ADDENDUM NUMBER 2

MILWAUKEE COUNTY ZOOLOGICAL GARDENS
AQUATIC REPTILE CENTER
HVAC EQUIPMENT REPLACEMENT AND
SOLAR WATER HEATING SYSTEM ADDITION
Site #355, Bldg. #4440
10001 West Bluemound Road
Milwaukee, WI

Project Number: Z014-09475

Date of Addendum: March 28, 2012

M1

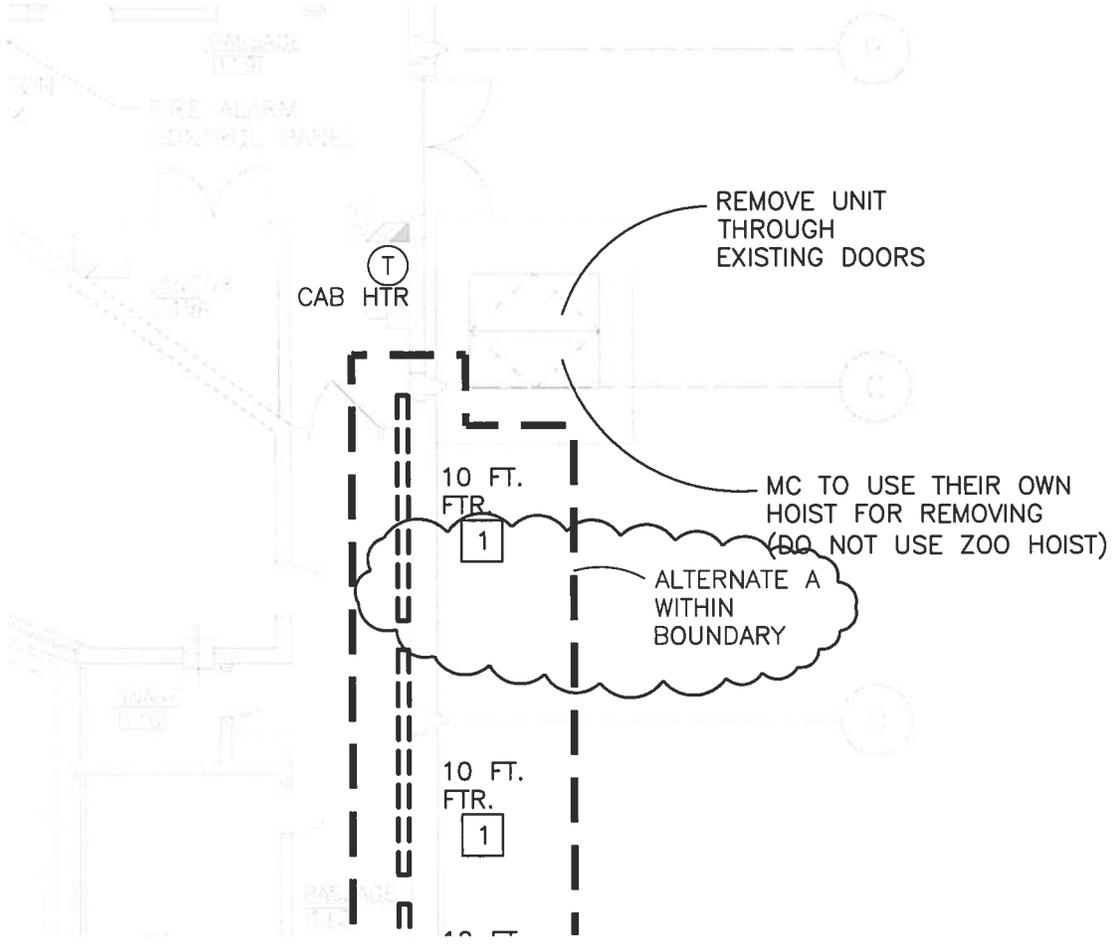
20. Add detail bubble, revise Alternate bid identification and detail notes as shown in attached sketch M1 attached to this addendum.

21. Add detail bubble, revise Alternate bid identification and detail notes as shown in attached sketch M1 attached to this addendum.
22. Revise Alternate Bid A note for boundary and bid identification as shown in attached sketch M2.

1. REMOVE 3/4" RWS UP, CAP PIPE, PATCH FLOOR TO MATCH EXIST.
2. CUT EXIST 18/10 DUCT FOR NEW CONTROL DAMPER.

M2

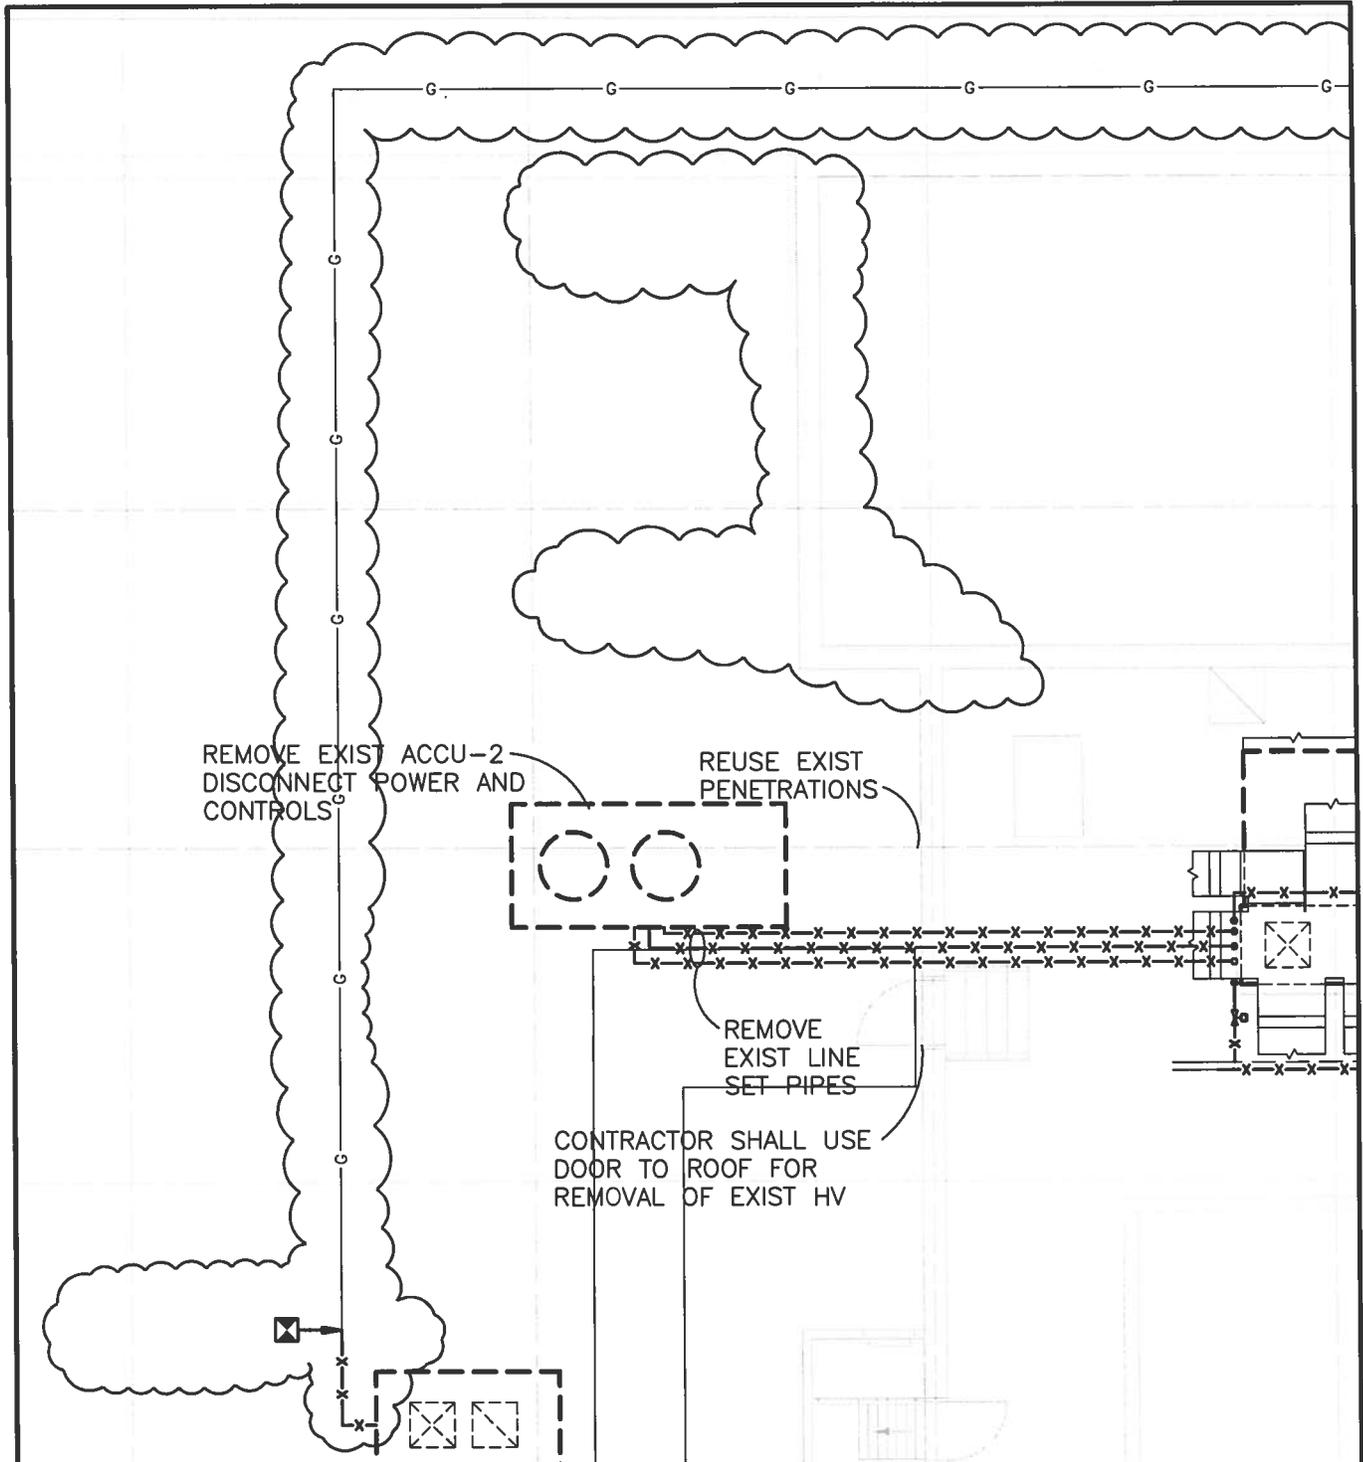
1. REMOVE EXIST FTR
2. REMOVE EXIST CONTROL WIRING TO FTR

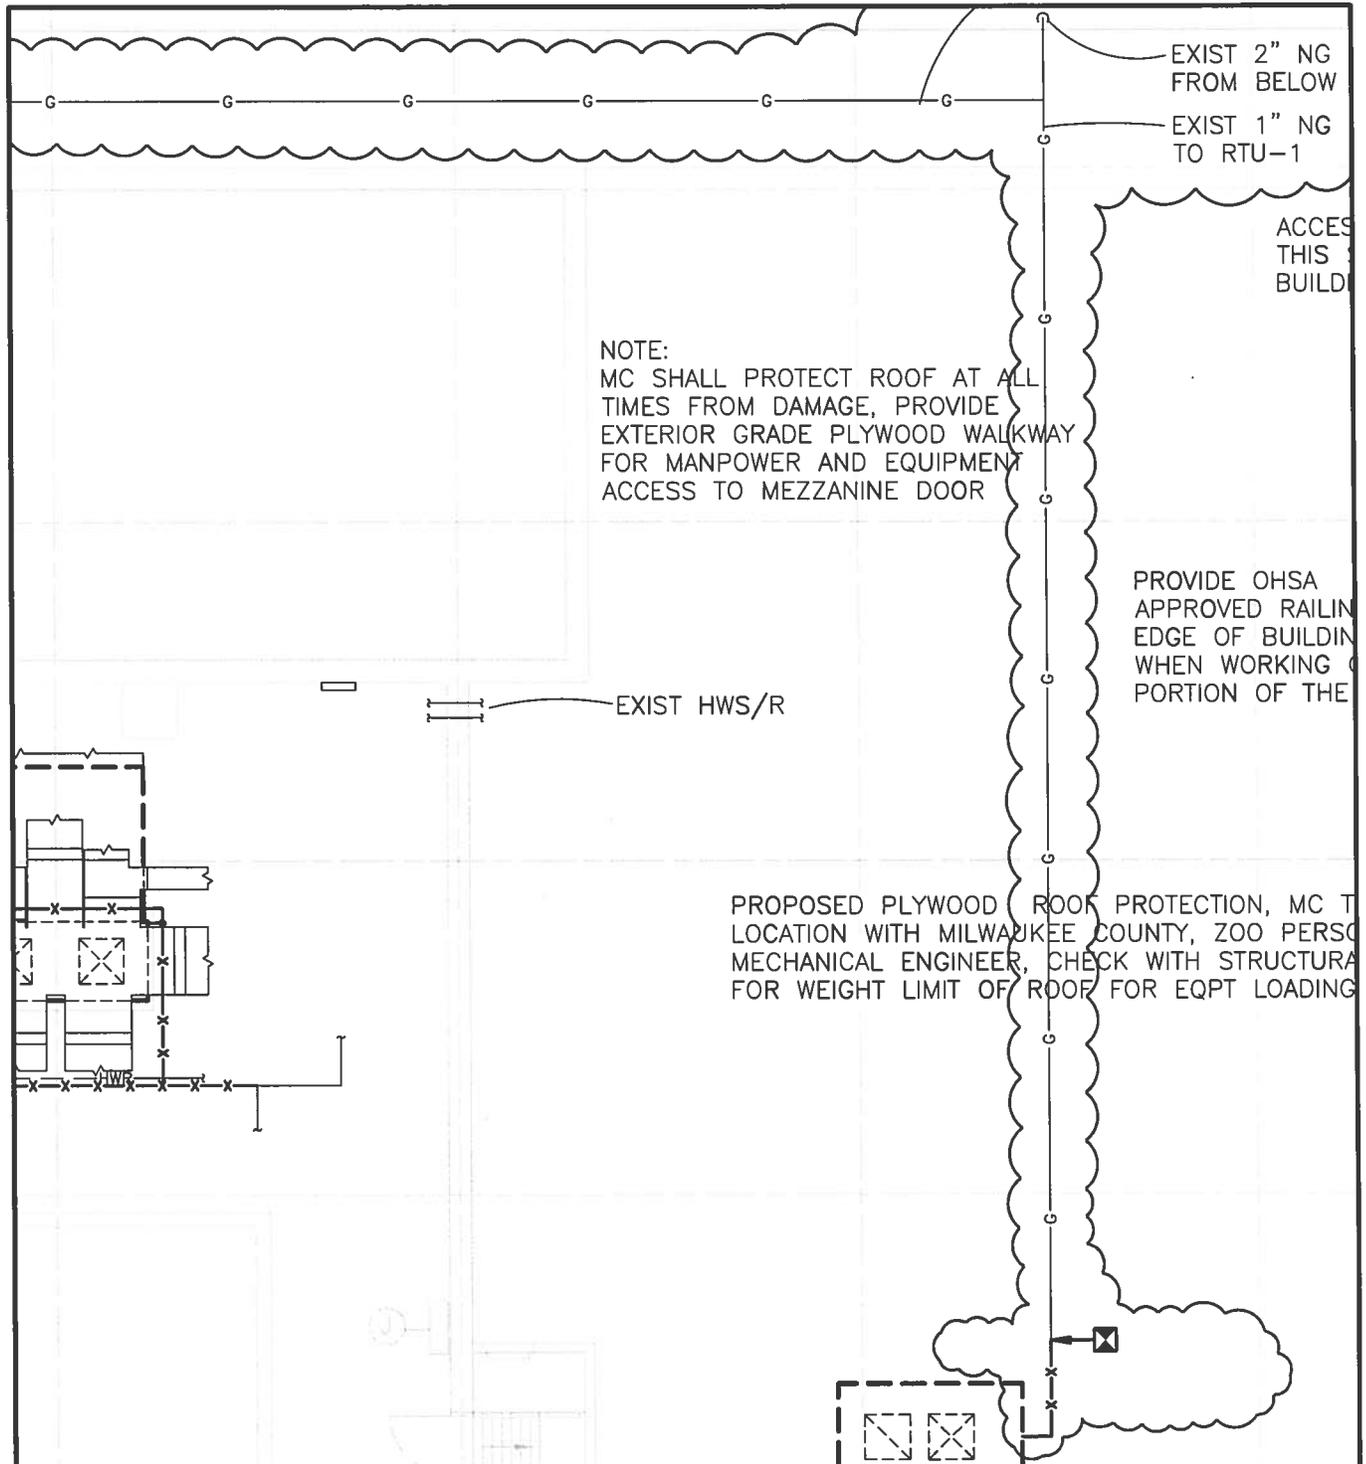
23. Add existing natural gas piping as shown in attached sketches M3, M4, & M5

M4

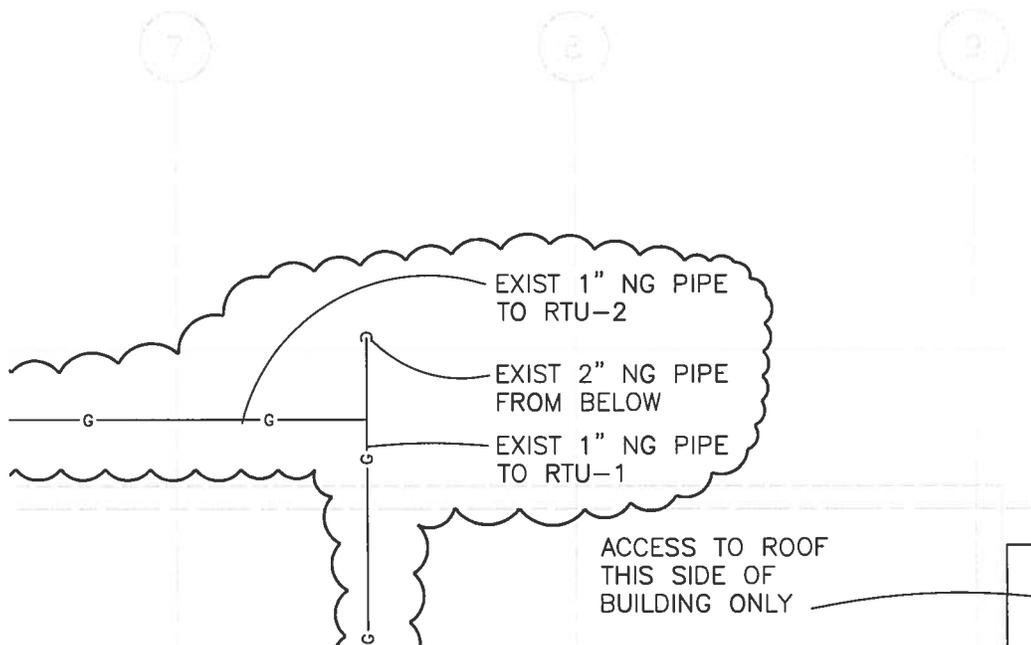
EXIST 2" NG
 FROM BELOW
 EXIST 1" NG
 TO RTU-1

M5

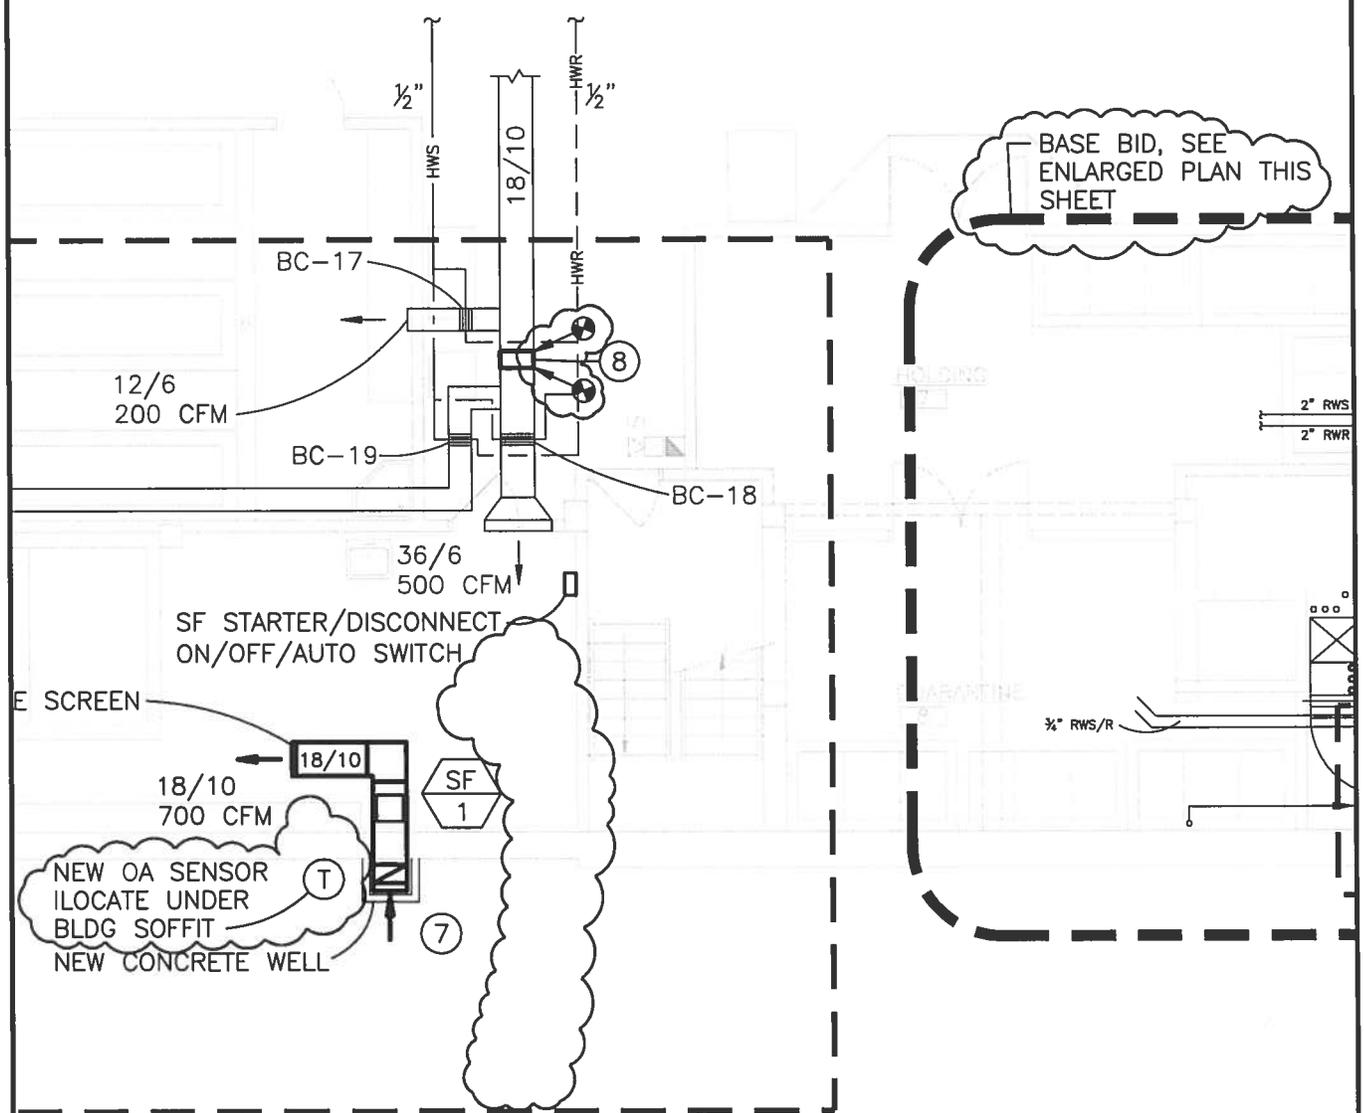
1. REMOVE EXISTING AHU-2, DISCONNECT POWER, CONTROLS, DUCTWORK AND PIPING.
2. REMOVE TWO SUPPLY AIR OUTLET DUCTS FROM AHU-2 TO PLENUM.
3. DISCONNECT LINE SETS AND HWS/R.
4. DISCONNECT CONDENSATE DRAIN.
5. DISCONNECT AHU-2 AT FILTER BOX AND RETURN DUCT.

M7

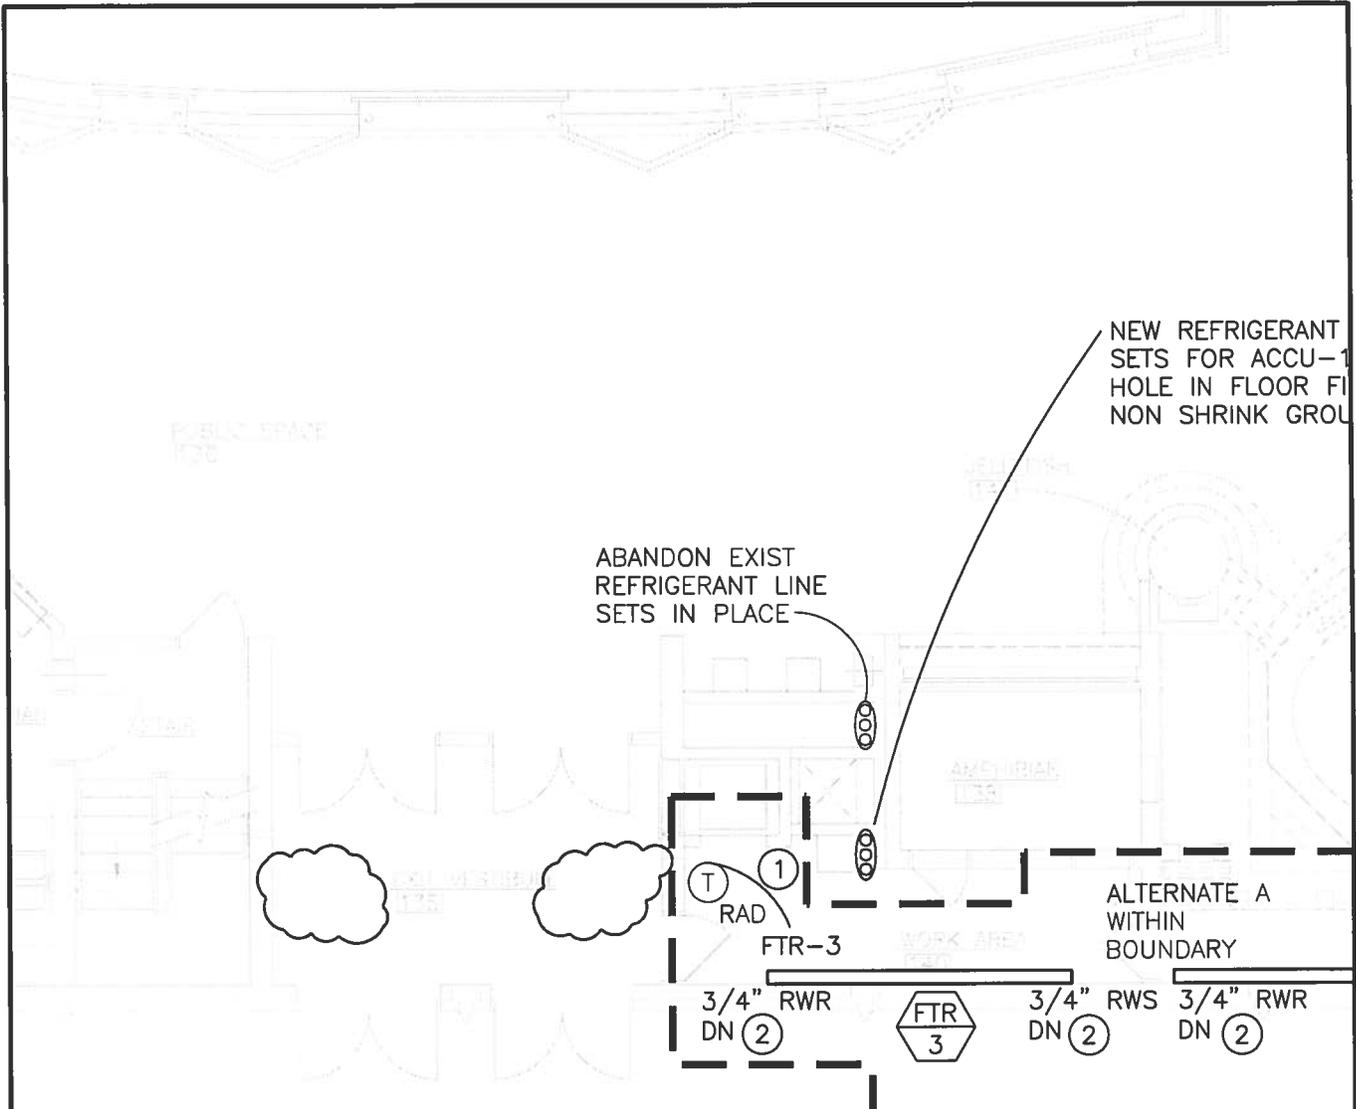
24. Relocate OA sensor and add control damper point of connection as shown in attached sketch M6.
25. Add Alternate A notes, equipment tags and detail call-outs as shown in attached sketch M7.

1. CORE NEW HOLE IN FLOOR, PROVIDE NEW $\frac{3}{4}$ " RWS UP TO NEW FTR-1
2. CORE NEW HOLE IN FLOOR, PROVIDE NEW $\frac{3}{4}$ " RWR UP TO FTR-1. SEE DETAIL FOR VALVES AND CONTROLS.
3. CORE NEW HOLE IN FLOOR, PROVIDE NEW $\frac{3}{4}$ " RWS TO FTR-2
4. CORE NEW HOLE IN FLOOR, PROVIDE NEW $\frac{3}{4}$ " RWR UP TO NEW FTR-2. SEE DETAIL FOR VALVES AND CONTROLS.
5. CORE NEW HOLE IN FLOOR, PROVIDE NEW $\frac{3}{4}$ " RWS UP TO FTR-3
6. CORE NEW HOLE IN FLOOR, PROVIDE NEW $\frac{3}{4}$ " RWR UP TO FTR-3. SEE DETAIL FOR VALVES AND CONTROLS.
7. NEW FILTERED IN-TAKE HOOD, SEE DETAIL
8. PROVE NEW 18/10 CONTROL DAMPER. DAMPER IS NORMALLY OPEN, INTERLOCK TO SF-1 FOR CONTROL DAMPER. CONTROL DAMPER SHALL CLOSE WHEN SF-1 IS OPERATING. PROVIDE ON/OFF/AUTO SWITCH. WHEN OA SENSOR IS 70°F OR ABOVE, START SF-1 AND CLOSE CONTROL DAMPER.

CUT IN NEW CONTROL VALVE AND ACTUATOR. WIRE CONTROL TO SOLAR SYSTEM. CLOSE 90% WHEN SOLAR IS ON, OPEN 100% WHEN SOLAR IS OFF.

M8

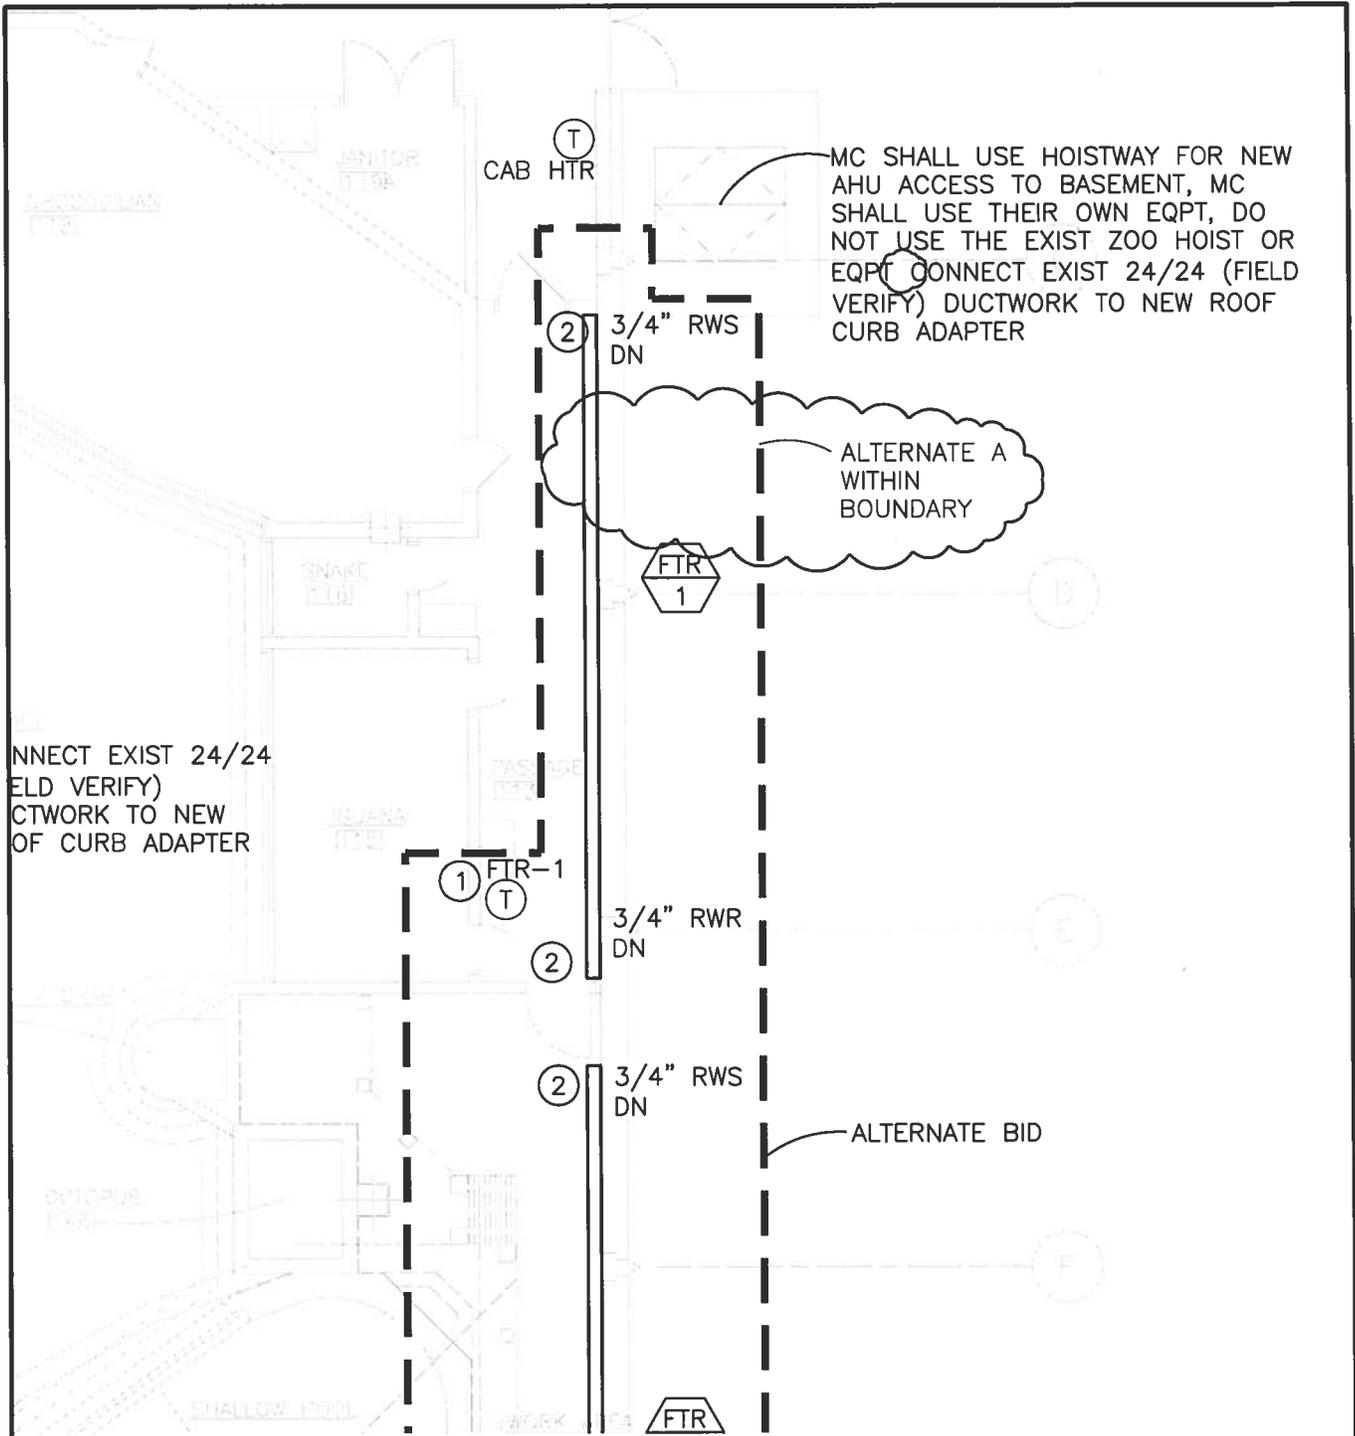
26. Remove existing t-stats symbols in vestibule and revise Alternate 1 to Alternate A as shown in attached sketch M8.
27. Move existing Alternate A note out of boundary and add space between note at "eqpt connect". as shown in attached sketch M9.

1. PROVIDE NEW CONTROL WIRING TO NEW FTR CONTROL VALVE AT EXISTING HVAC THERMOSTAT, EXISTING CONTROL DEVICES SHALL REMAIN IN SERVICE
2. CORE HOLE IN FLOOR FOR NEW PIPE
